**MAINE TURNPIKE AUTHORITY**

**ADDENDUM NO. 1**

**CONTRACT 2024.04**

**PAVEMENT REHABILITATION**  
**EXIT 75 AUBURN**

SHEET NUMBER: P-2

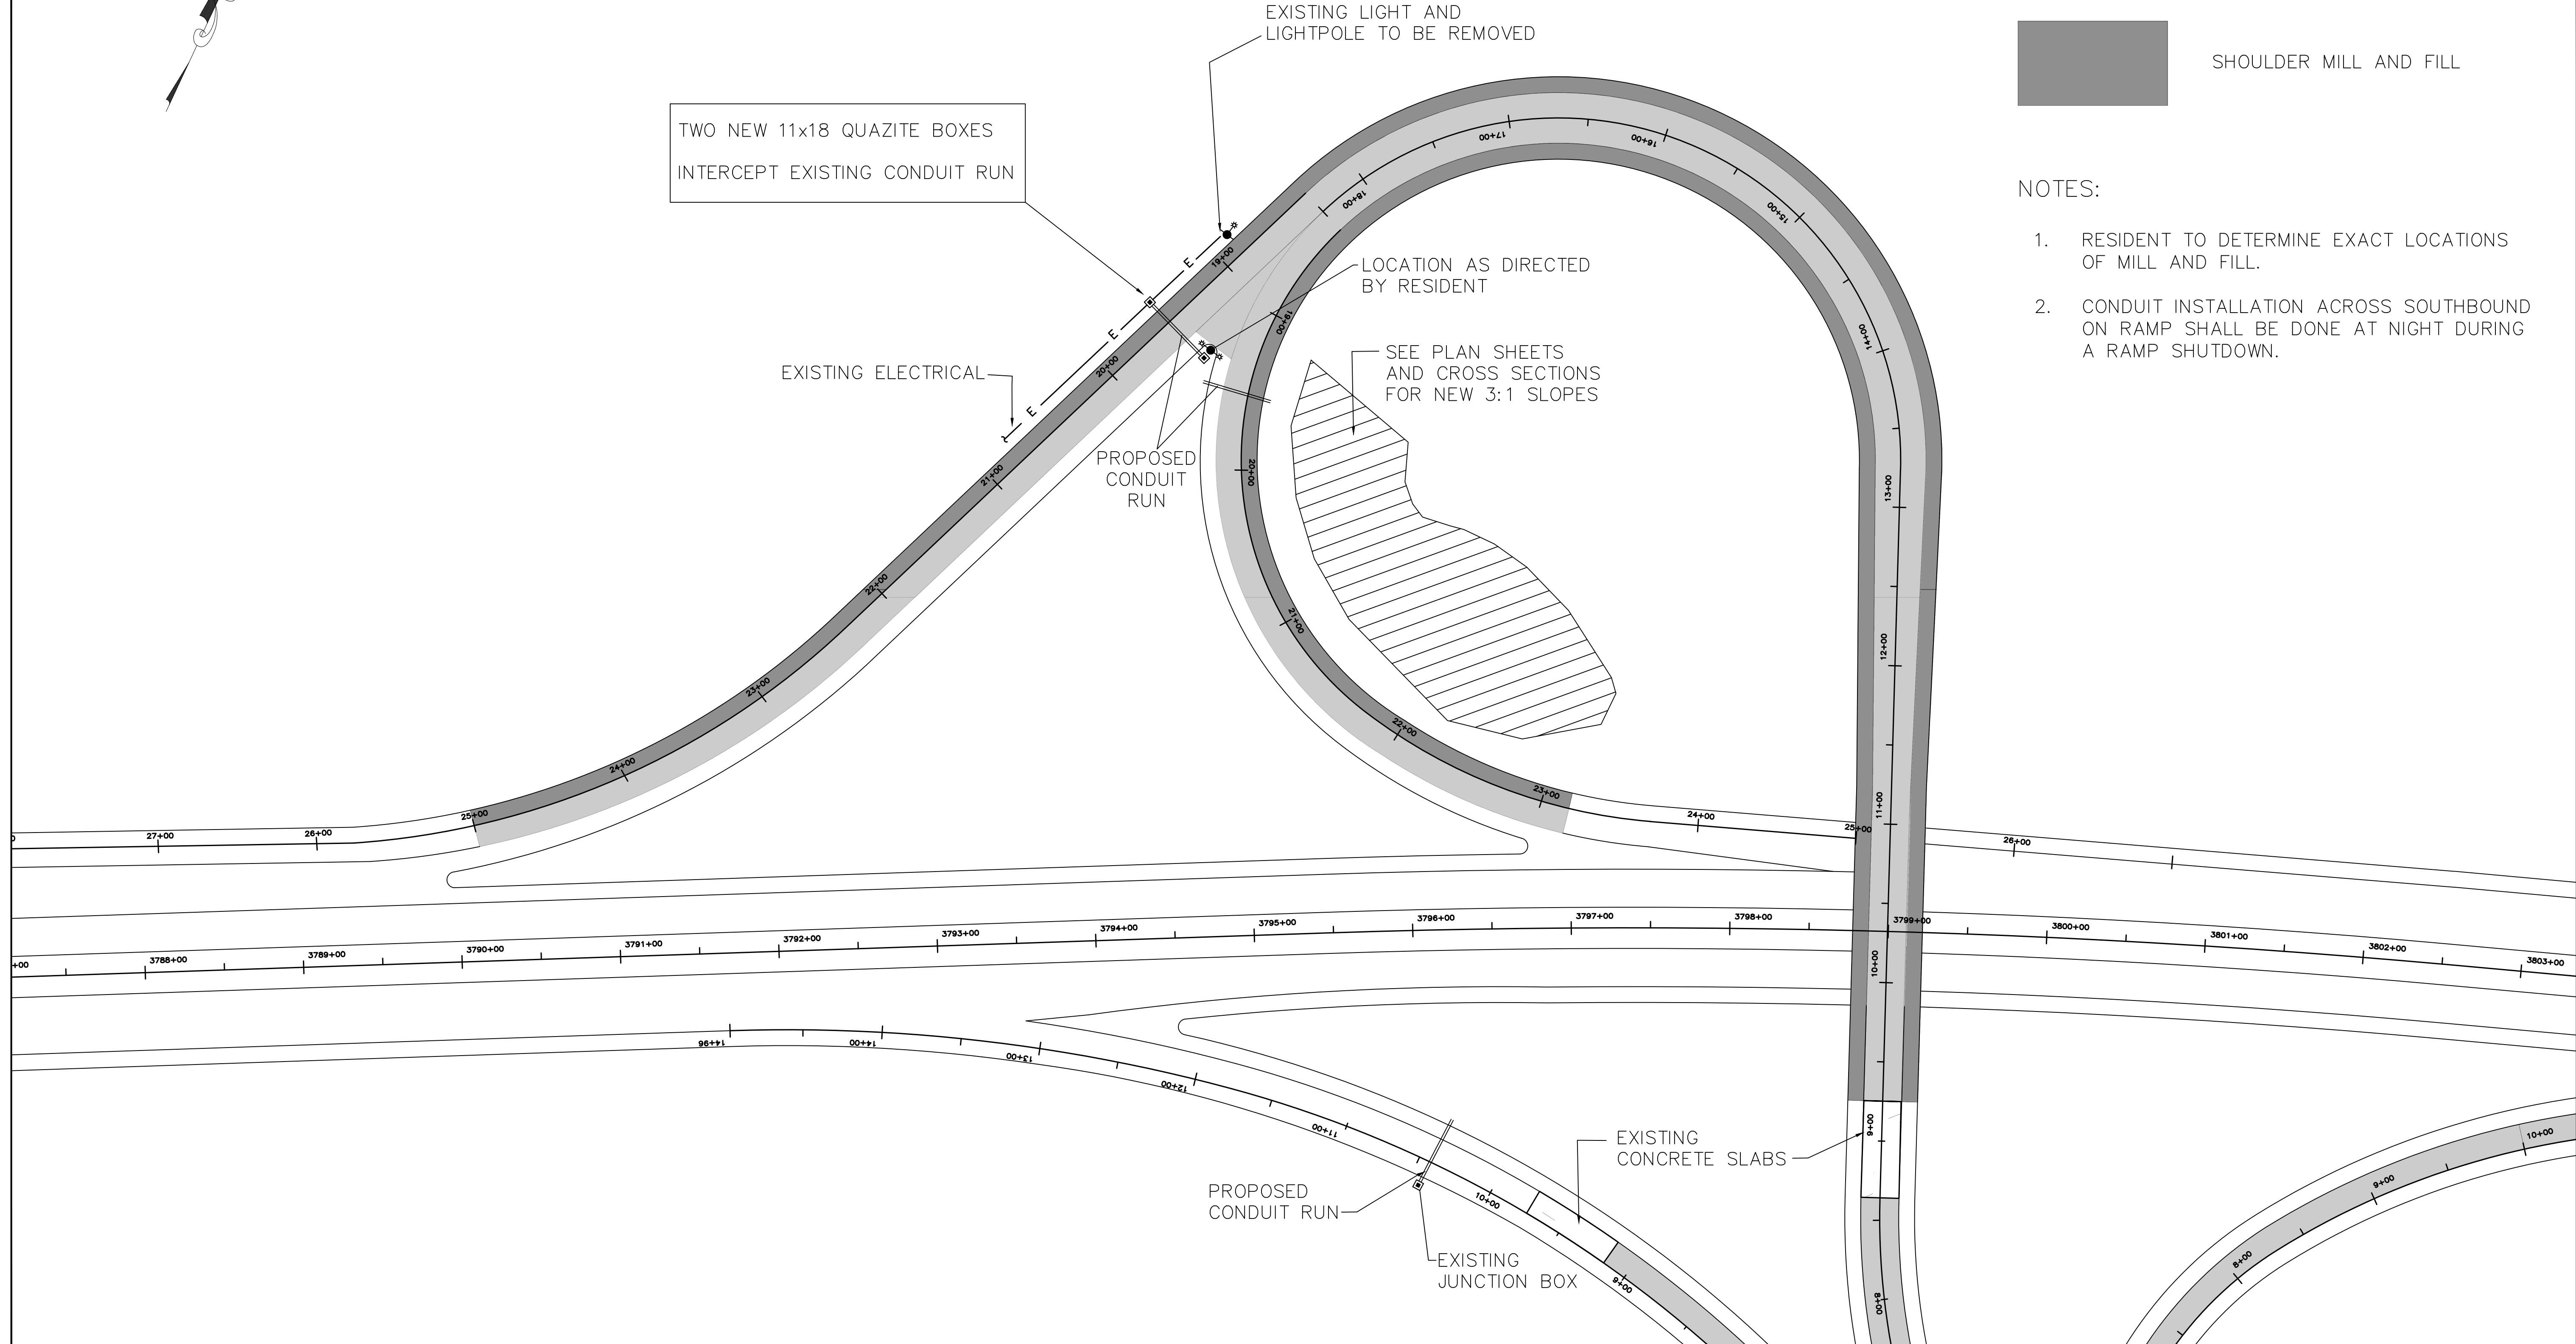
Remove Plan Sheet 4 and Plan Sheet 10 and replace with attached.

- NOTES:
1. RESIDENT TO DETERMINE EXACT LOCATIONS OF MILL AND FILL.
  2. CONDUIT INSTALLATION ACROSS SOUTHBOUND ON RAMP SHALL BE DONE AT NIGHT DURING A RAMP SHUTDOWN.
